e _____ SPR-1995-009

FILE #SPR-95-9

TITLE HEADING: Site Plan Review - Building
Materials Sales

Re: Our File #SPR-95-9

SITE PLAN 0.704 ACRES

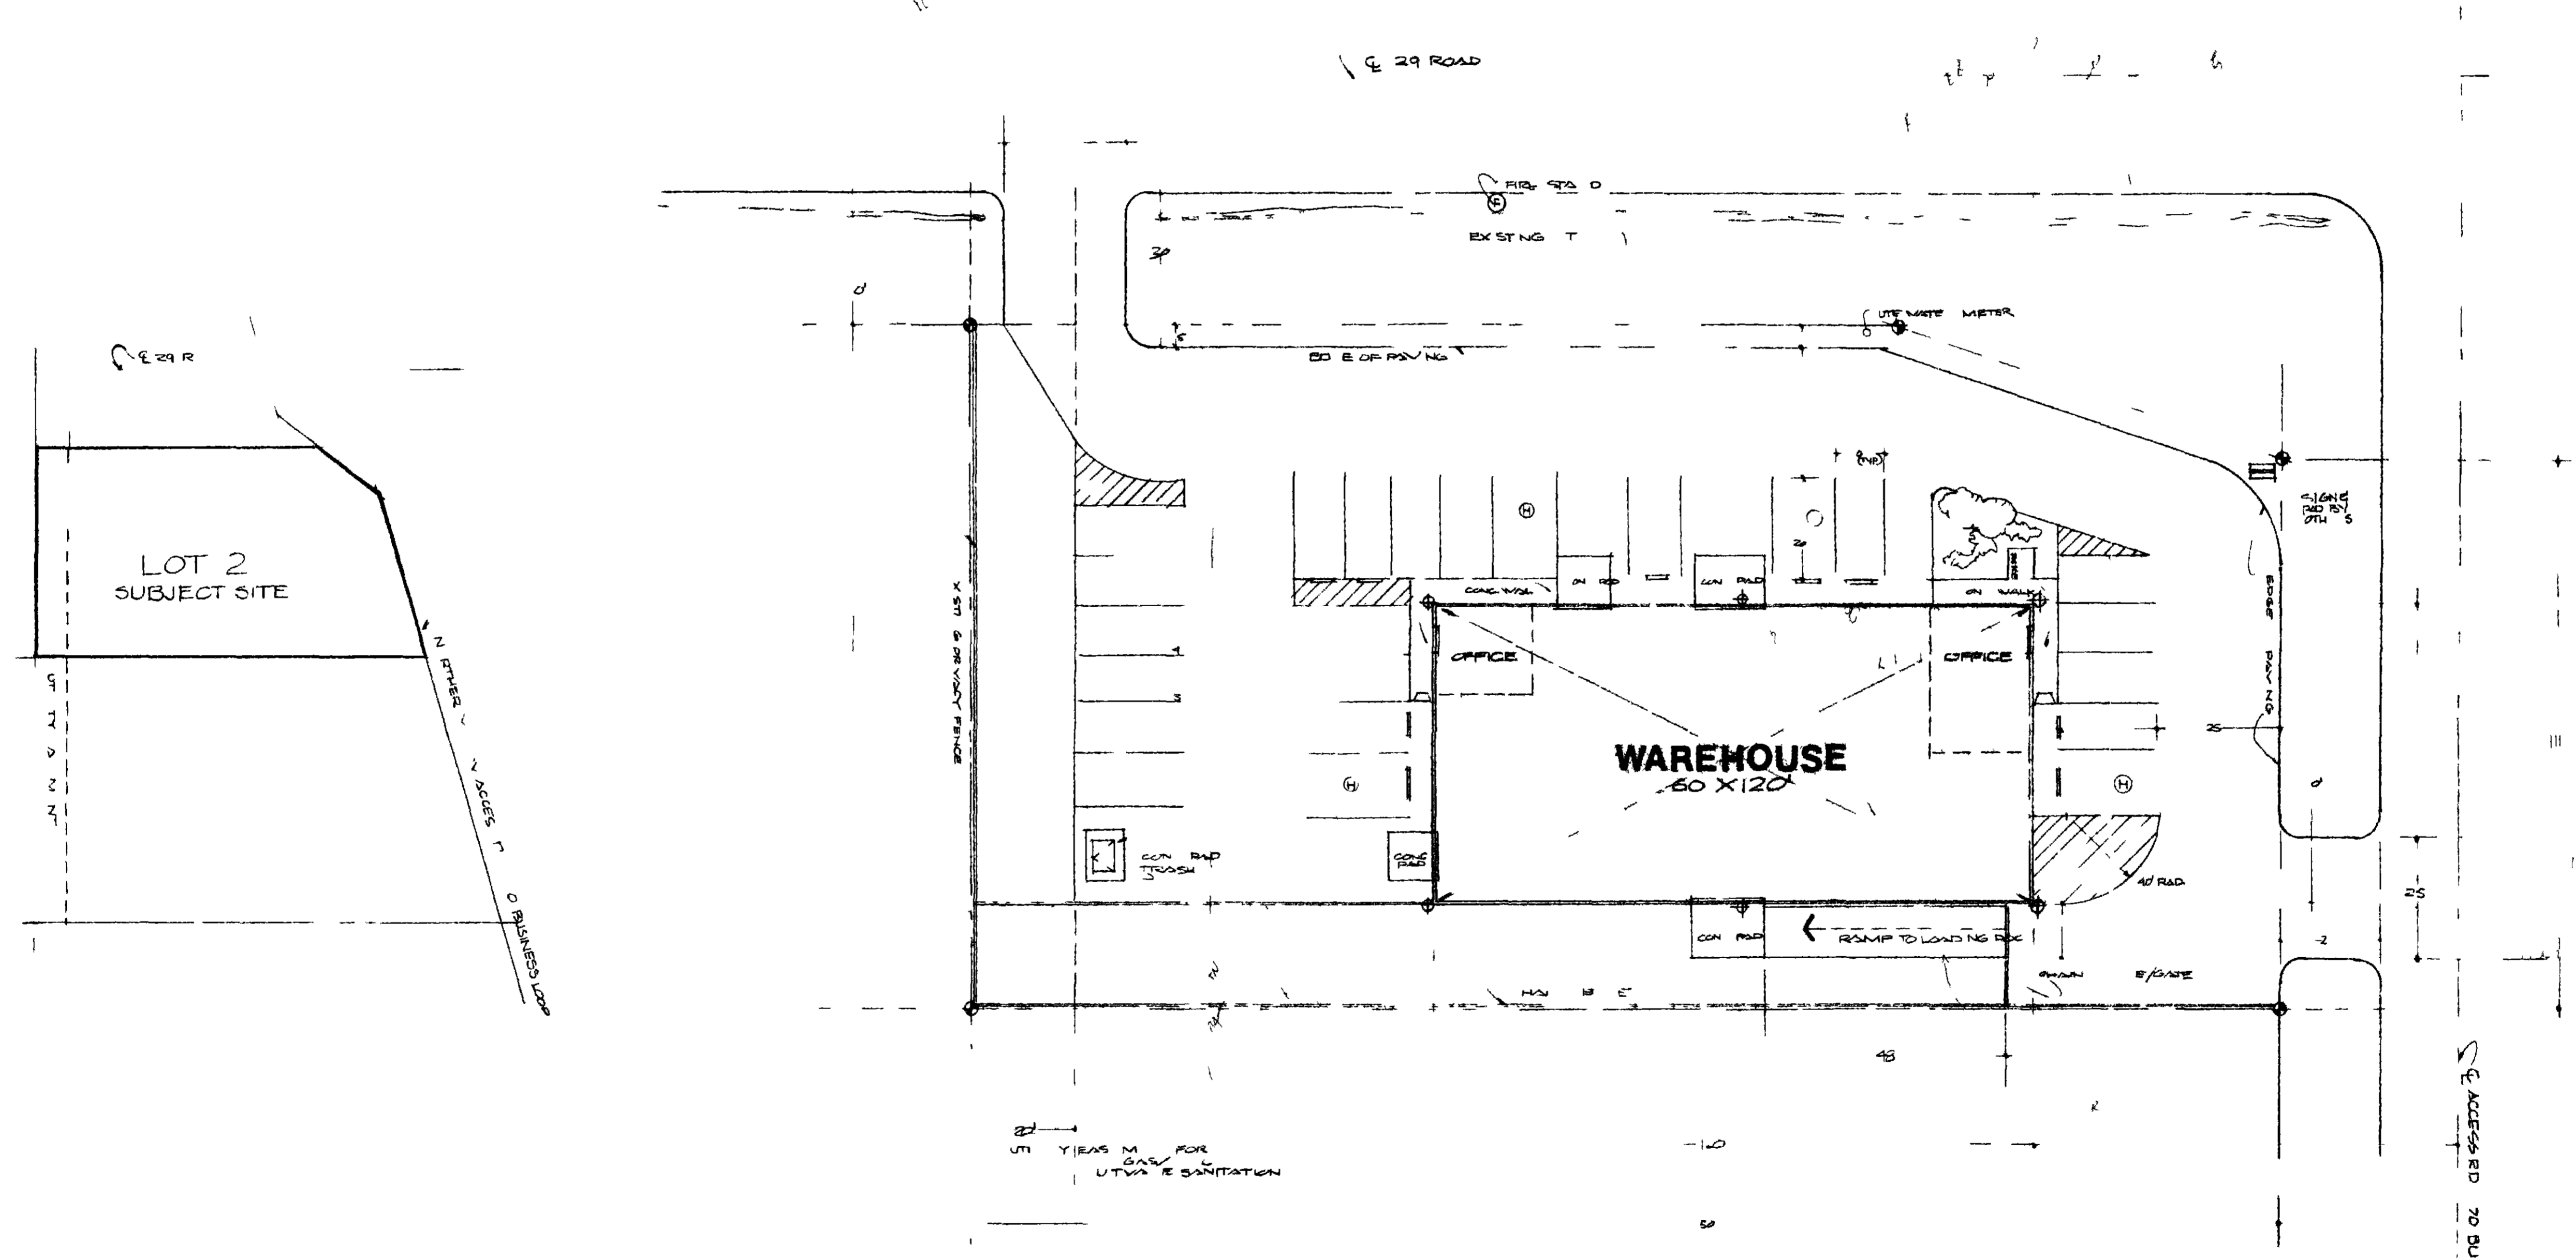
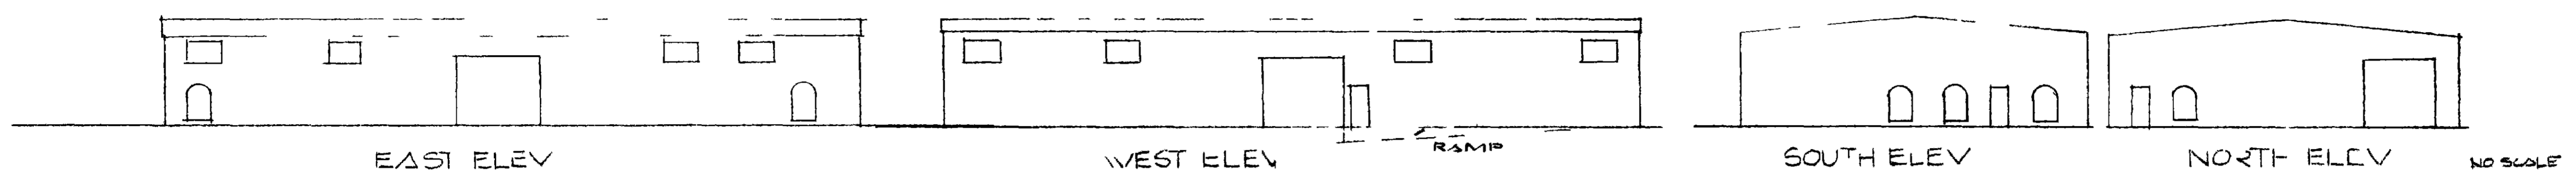
The site plan indicates limited landscaping. More would seem to be appropriate. No landscaping is indicated for the retention pond. Is the pond a "retention" or "detention" facility? What type of grass, if any, is proposed for the "yard"? Does the trash container need to be screened? Need to more clearly define the location of the sign. Two driveway locations would seem to be appropriate.

1. 29 Road is a principal arterial and requires 110' of total right-of-way. Dedication of sufficient right-of-way is required so that there will be 55' of half right-of-way. Submitted drawings show less than 30' of existing half right-of-way.

4. Parking spaces need to be dimensioned and must meet the Zoning and Development Code requirements. One handicap space is required and must be signed, marked and meet dimensions in City Standards. A ramp to the sidewalk to enter the building is required and must meet ADA requirements.

1. Section 5-5-1 F(1) of the Zoning and Development Code requires that at least five percent of the parking lot area shall be used for landscaping. Our calculations indicate that about 375 square feet is provided whereas 820 square feet of landscaping is required. The amount of required landscaping would be reduced if the minimum parking as per Code would be provided.

2. The frontage landscaping is sufficient in size, however, much of it appears to be in the ROW of 29 Road. We would recommend that the parking along the building on the 29 Road frontage be eliminated (since it is not required by Code) or converted to parallel parking spaces and the driveway width narrowed which would allow for the frontage landscaping to be located on the property (a maximum of 15% of the frontage landscaping may be located in the ROW as per Code). Also indicate groundcover to be used along frontage between the landscaping and the street.

3. Landscape Plan is incomplete, see attached checklist for remaining items (minor).
4. All landscaped areas should be protected by concrete curbing; please identify curbing provided on the plan.

1. An additional five (5) feet of right-of-way dedication will be required. From the latest drawing it appears a substantial amount of the landscaping and drainage is in the ROW.
2. The Stormwater Management Manual (SWMM) requires a percolation test performed and certified by a licensed engineer be submitted for retention ponds. Calculations for the drainage need
